**STATE OF VERMONT
PUBLIC UTILITY COMMISSION**

Case No. 21-2939-NMP

NEIGHBOR INTERVENORS' BRIEF AND FINDINGS OF FACT

January 12, 2023

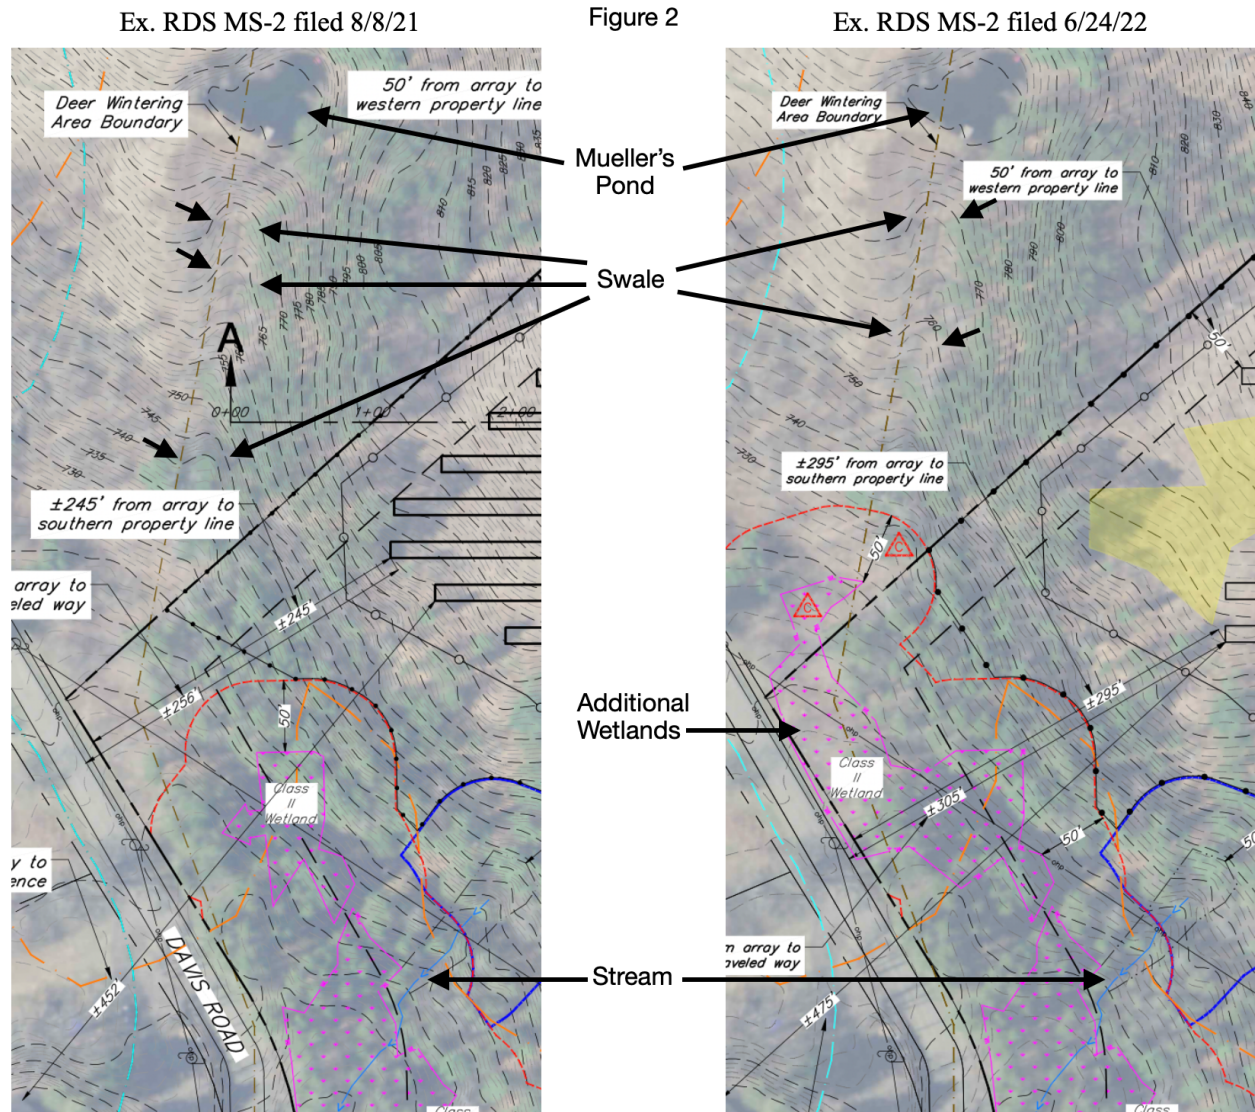
31. A perennial stream, not shown on any of the 6 site plans, runs in a very prominent swale from Mueller's pond [see figure 2], continues through or alongside the above mentioned class 2 wetlands, and then joins the stream that is shown on the site plan. The perennial stream and the class 2 wetlands are co-existent. The stream was flowing on March 25, 2021 and was viewed on that date by participants at the Site Visit.
Allen SurT p.5. Illustration is in Ex. NI JA-13. Allen PFT p. 12

Ms. Barton's stream assessment involved a review of LiDAR derived topography, but she overlooked a pond and swale that are very obvious on the LiDAR topography of the site plan. [See Figure 2] A perennial stream runs down the swale and into the class 2 wetlands.

Figure 3 RDS MS-2 filed 8/8/21

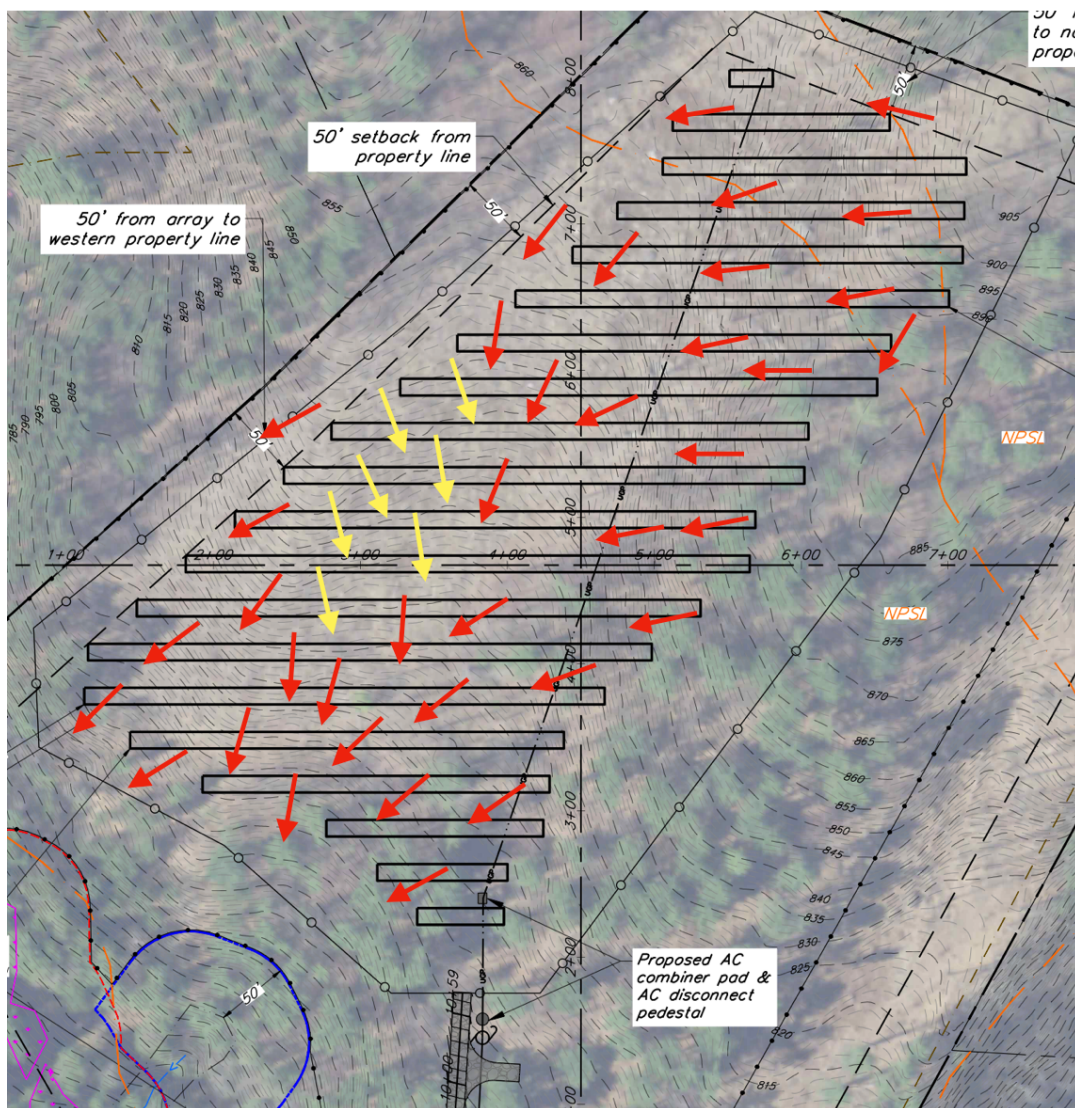
Ms. Barton asserts that the facility is generally sloped to the southeast, but the predominant slope is to the west and southwest. This is not a substantive issue, but it speaks to the reliability and credibility of Ms. Barton's testimony. See Figure 3.

Arrows point downhill.
